NOTICE TO CONTRACTORS - BID # 1415-143
BID TITLE "Carson City Animal Services Facility"
Labor Commissioner PWP# CC-2015-116
Engineer's Estimate: \$3,350,000

August 24, 2015

Addendum No. 3

A1 POWER PLAN - MECHANICAL
 1/8"=1'-0"

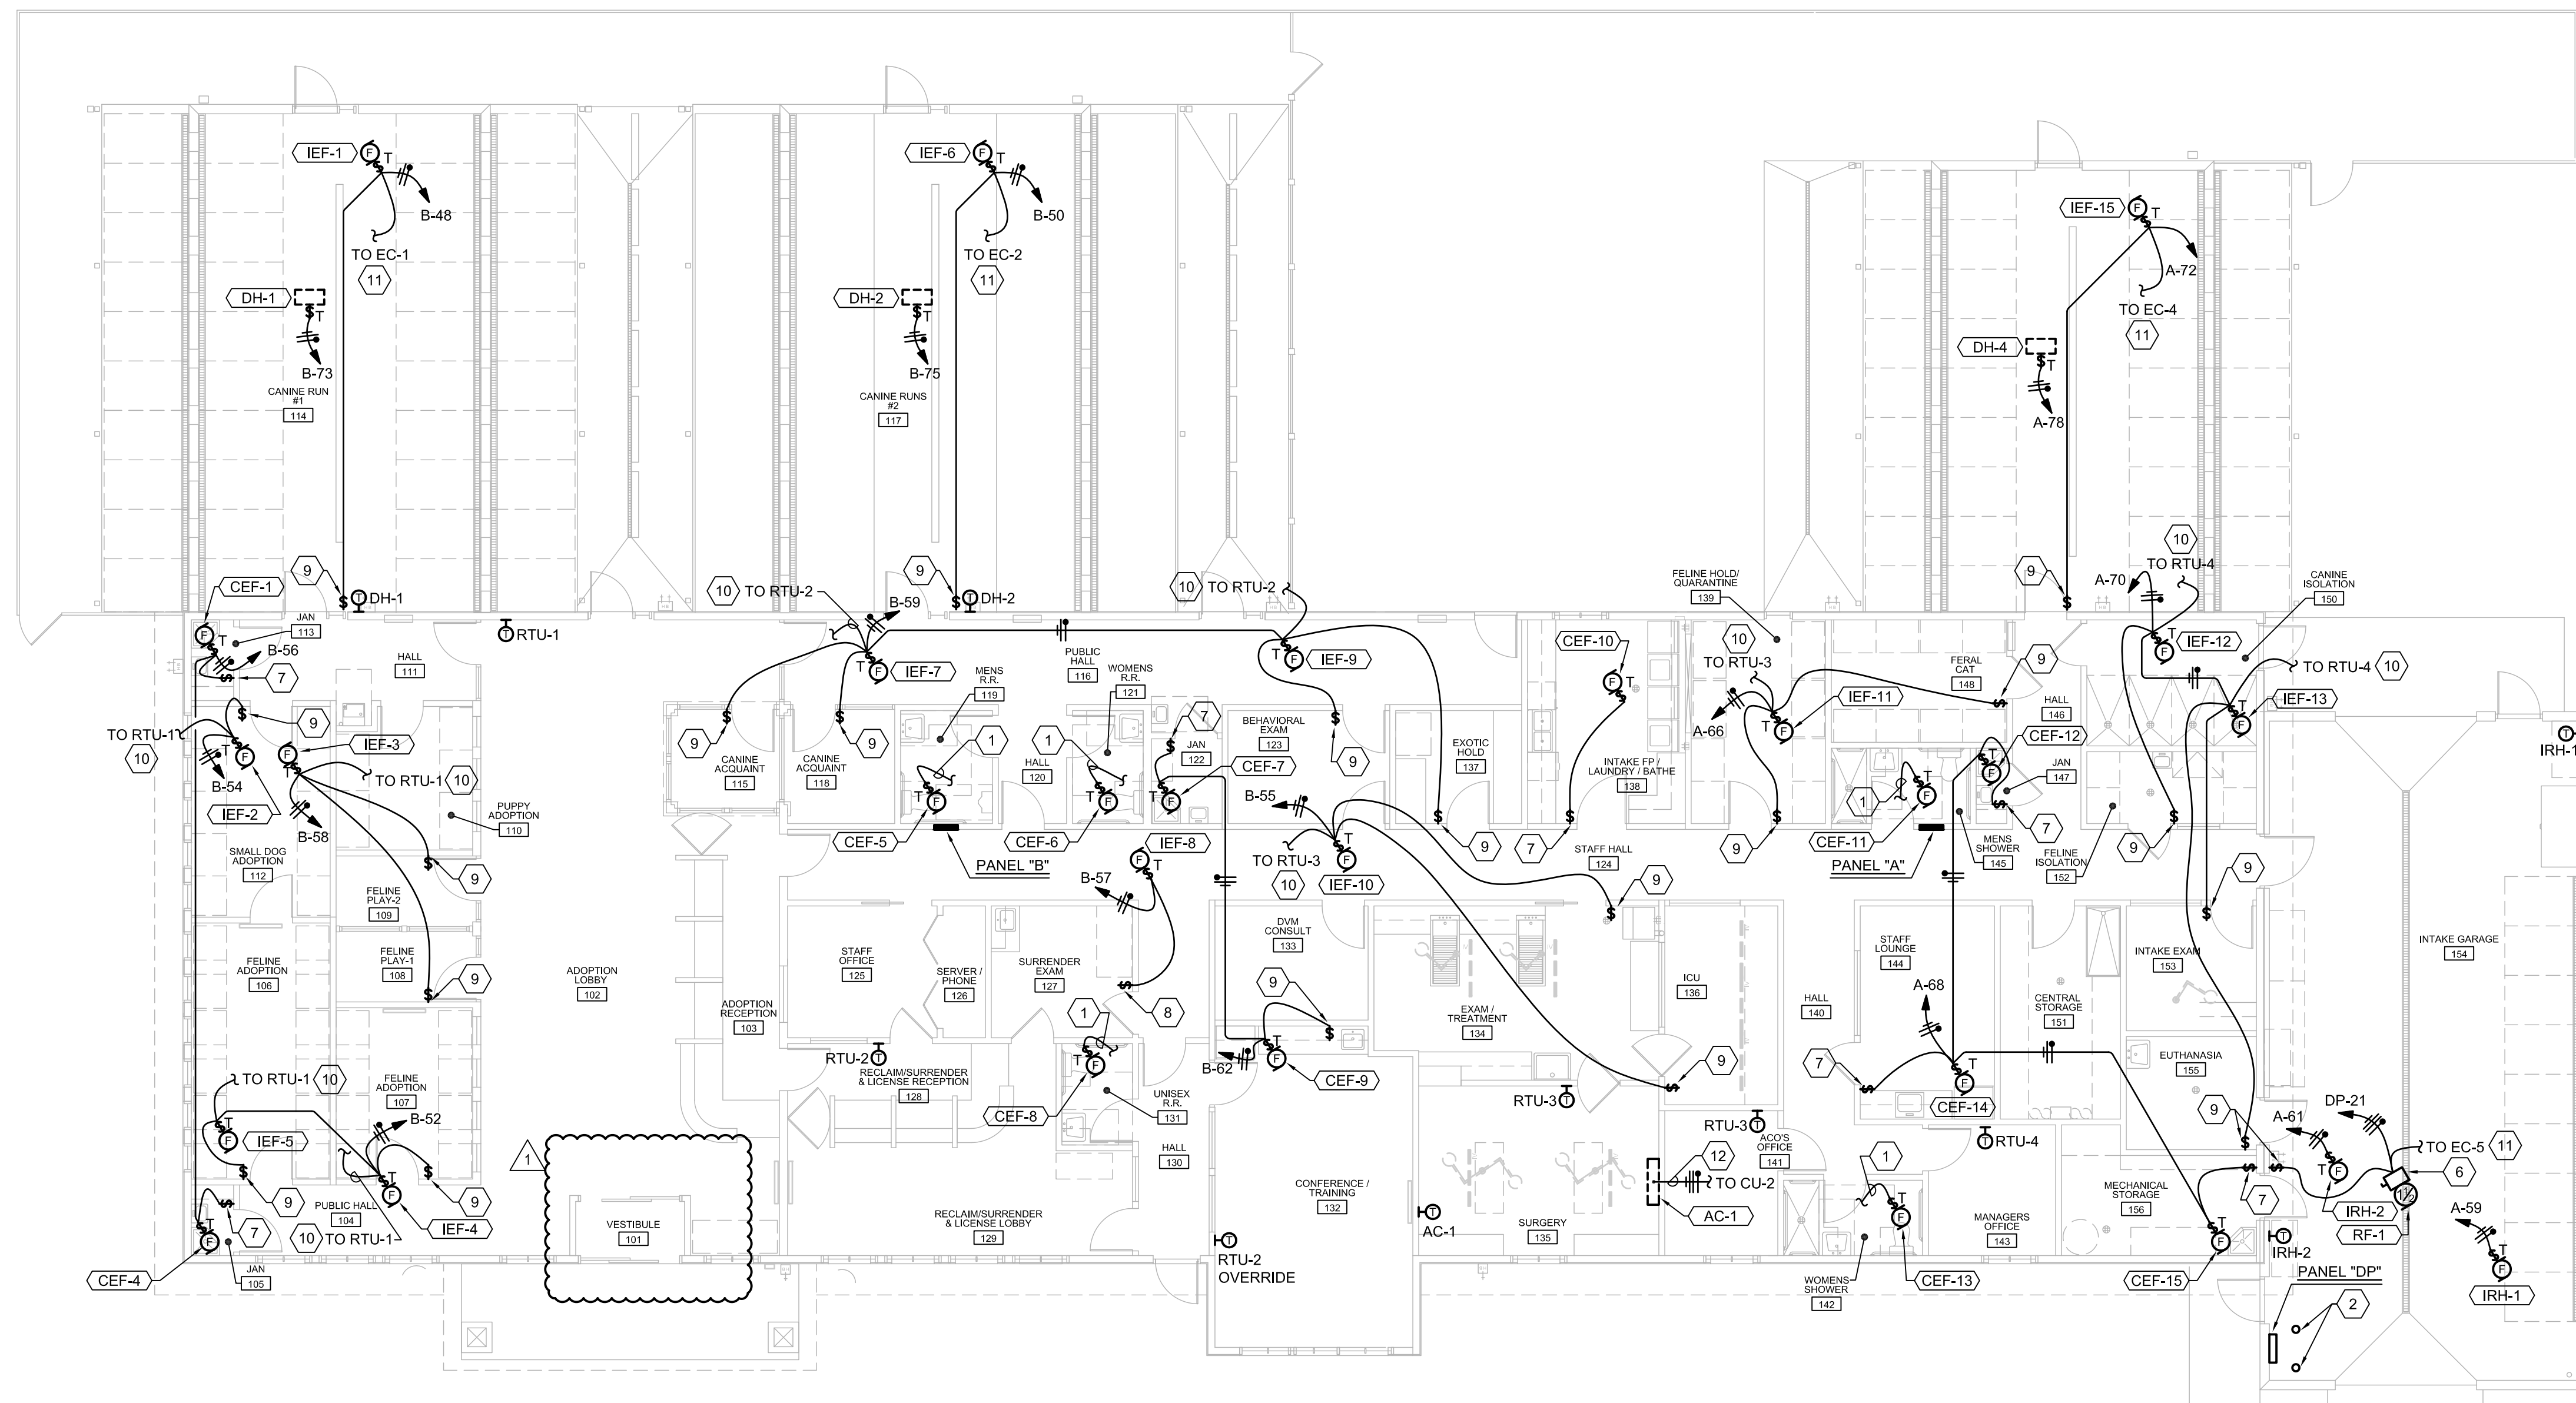
Clarification 1: *Modify & Replace Sheets E104, E201, M101 and M602, note the following:*

Remove both Electric Baseboard heaters. Modify associated power.

A1 MECHANICAL HVAC PLAN
1/8"=1'-0"
PROJECT NORTH

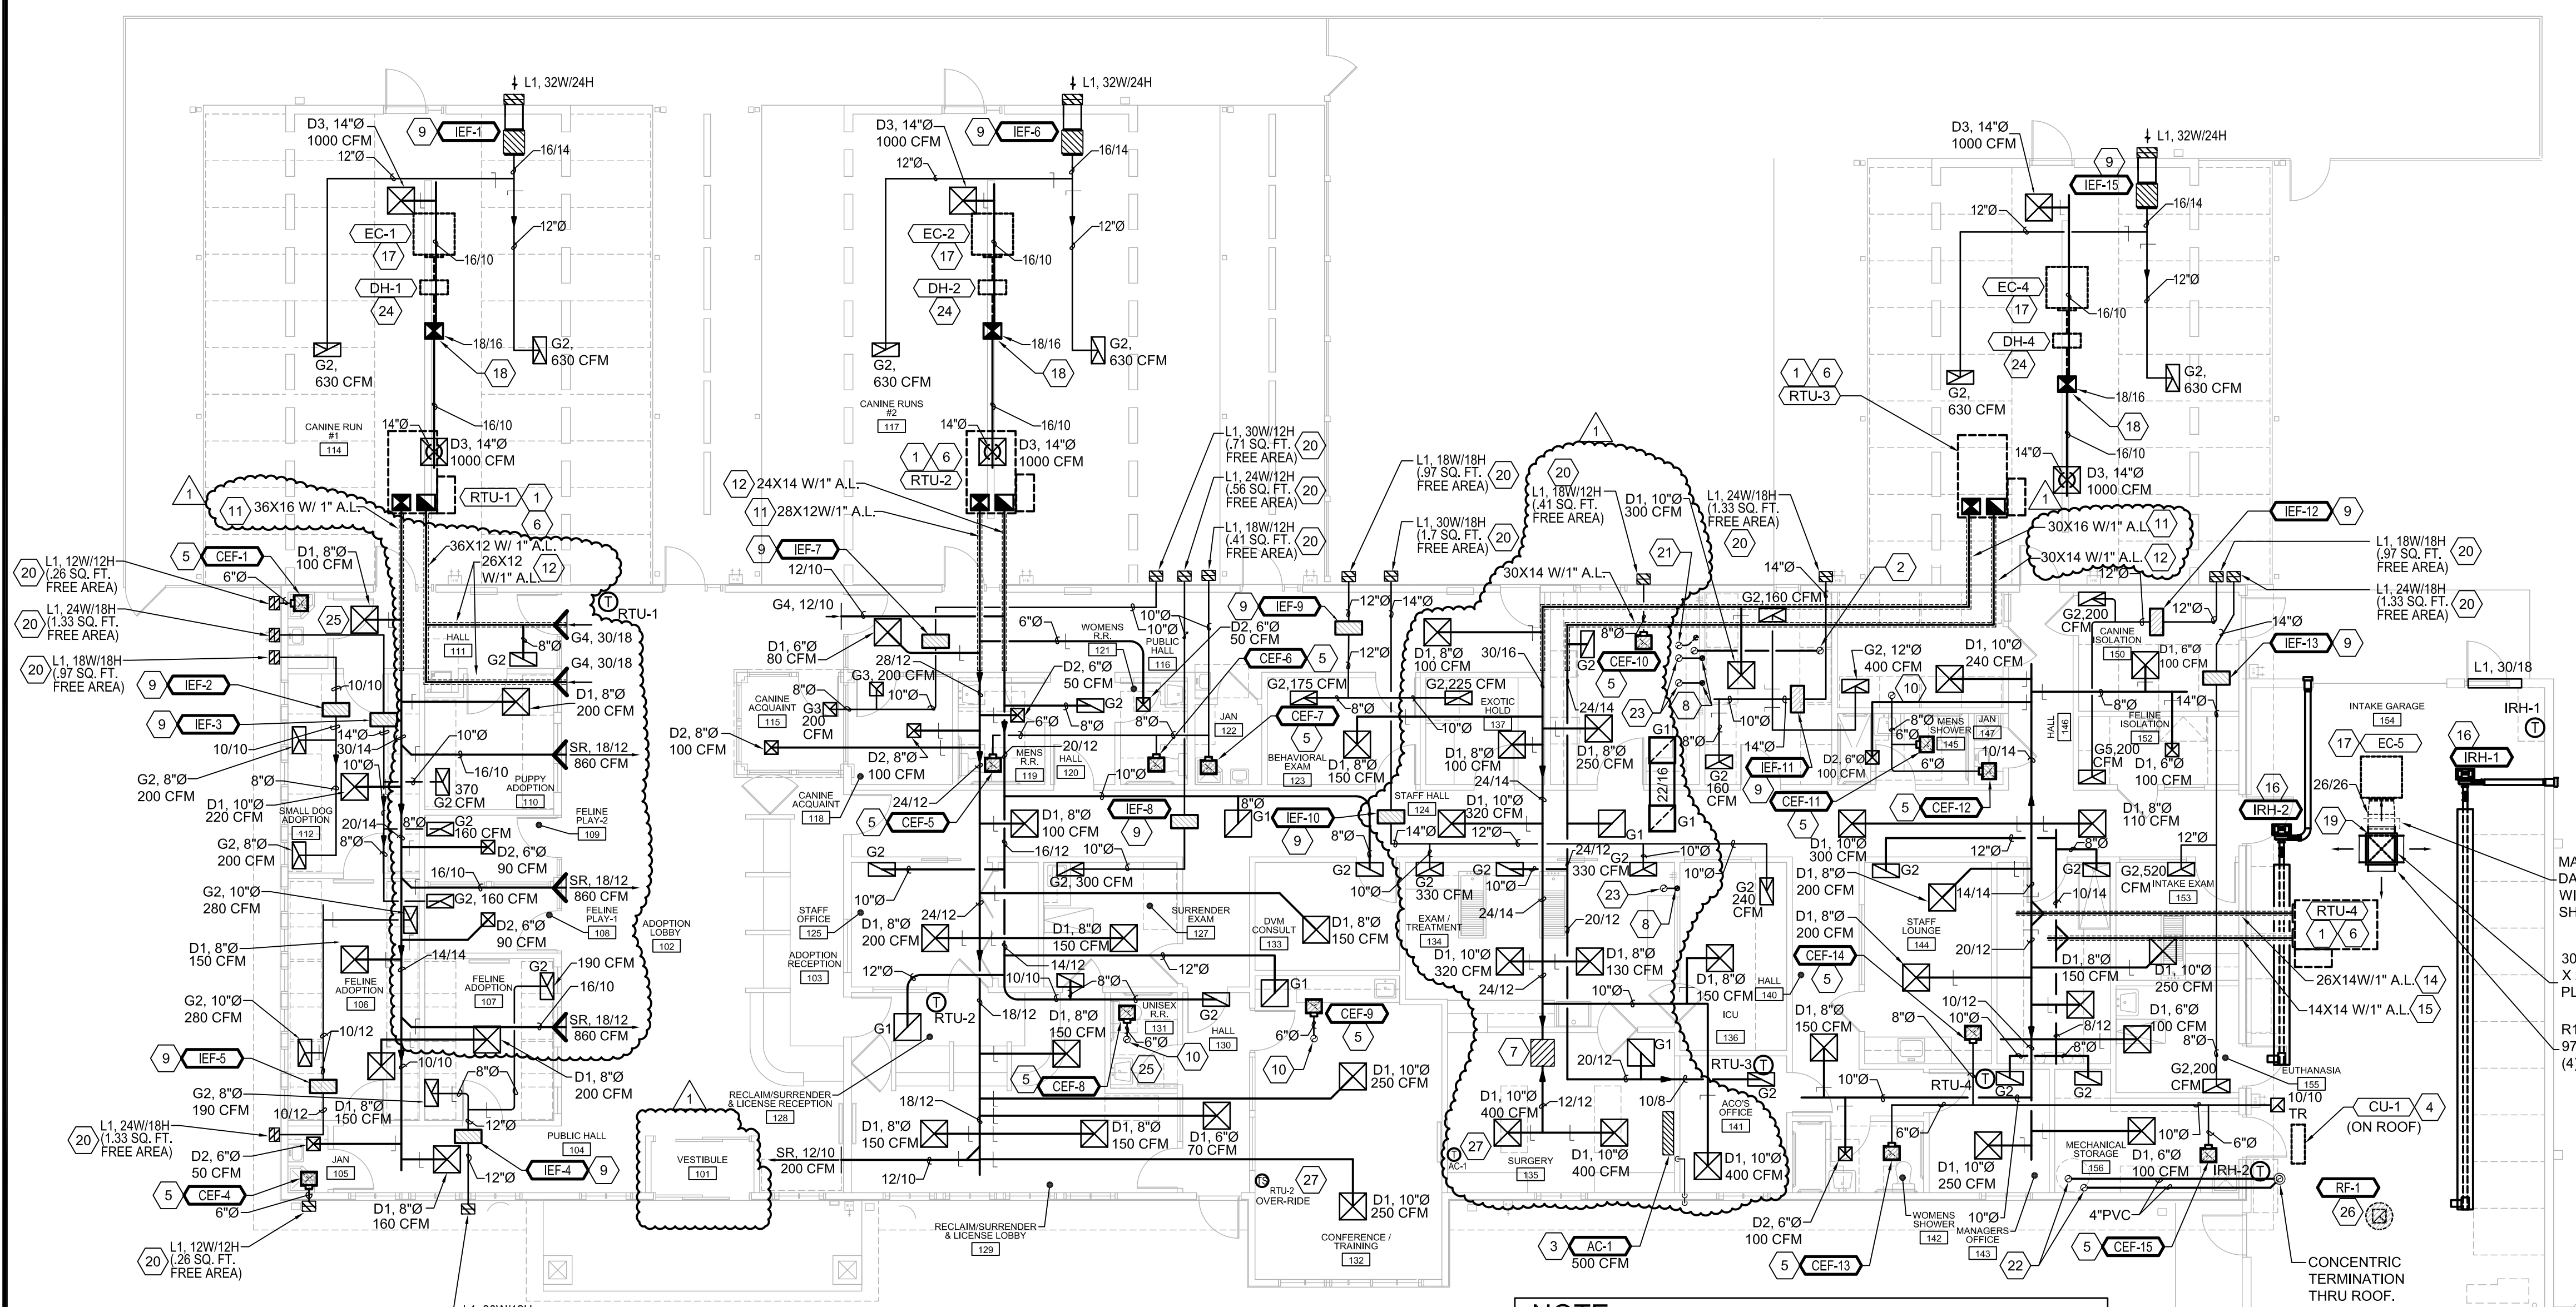
Revise RTU-1 and RTU-3 model numbers. Modify associated ductwork as shown on M101 along with associated power on electrical sheets. Approx. savings for these changes are \$20,000.
